CERTIFICATE OF APPROPRIATENESS

Property: 1330 Cortlandt Street, lot 22, block 168, Houston Heights Subdivision. The property includes a historic 4,301 square foot, two-story wood frame single-family residence and an attached garage and one story accessory structure situated on a 9,900 square foot (75' x 132') interior lot.

Proposal: Alteration – *Revision:* Window shutter installation, porch column, and front door replacement.

NORTH SIDE ELEVATION

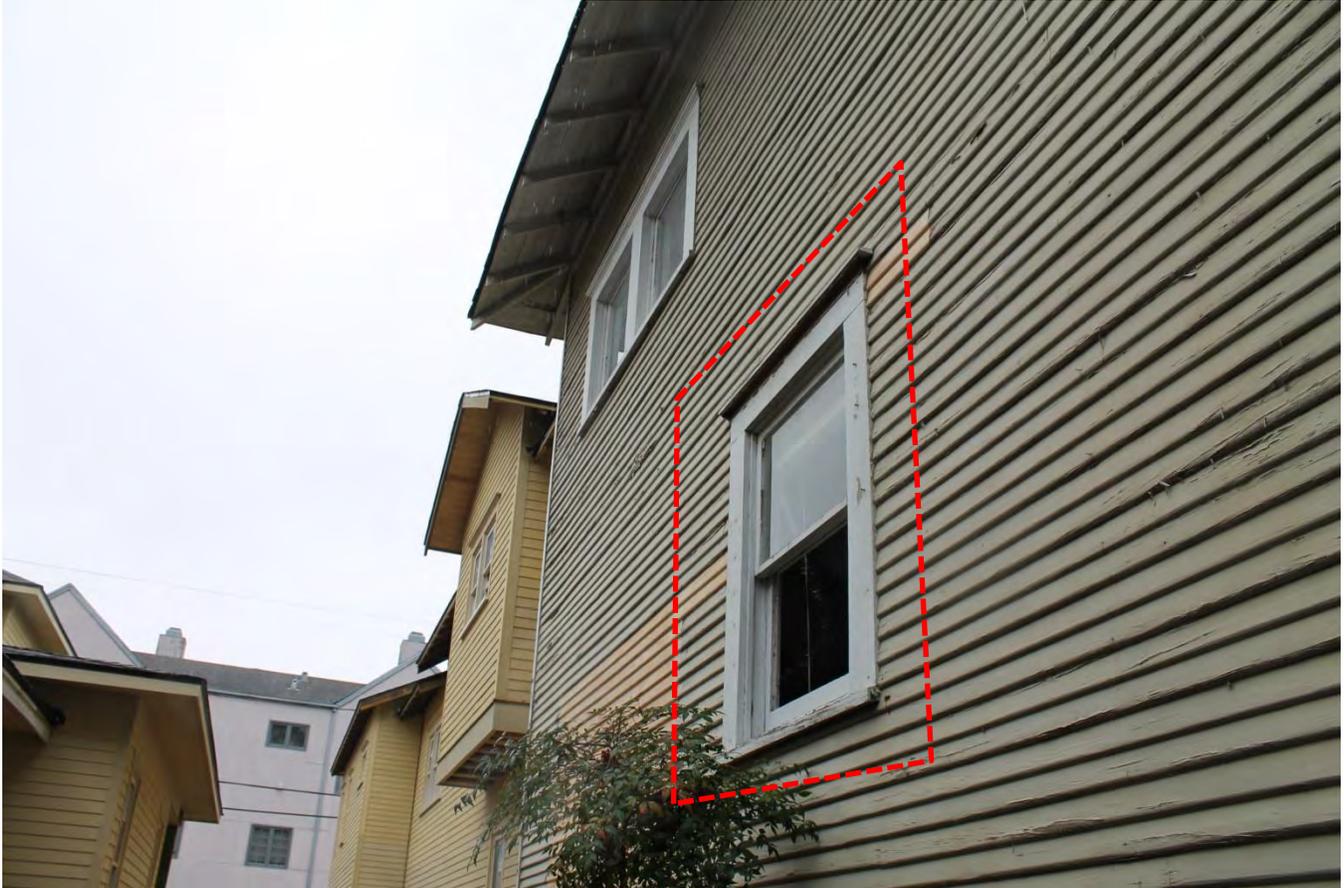
EXISTING WINDOW TO FEATURE FIXED SHUTTERS

Windows/Doors: Existing north facing first floor window, second from the front wall of the house, will be clad with a pair of fixed painted wood shutters.

DOOR SCHEDULE

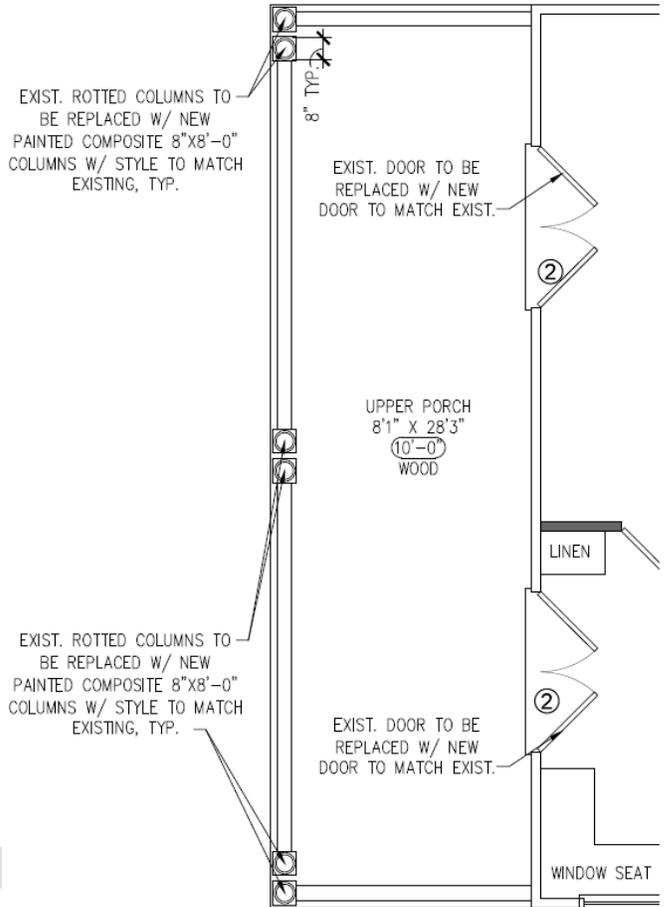
EXISTING FIRST FLOOR DOOR

PROPOSED FIRST FLOOR DOOR

EXISTING SECOND FLOOR DOORS

PROPOSED DOORS WILL MATCH EXISTING

The existing non-original façade features three wood divided lite doors: One single door flanked by a pair of sidelites and two pairs of French doors on the second floor balcony. These doors will be replaced with new wood divided lite replacement doors.
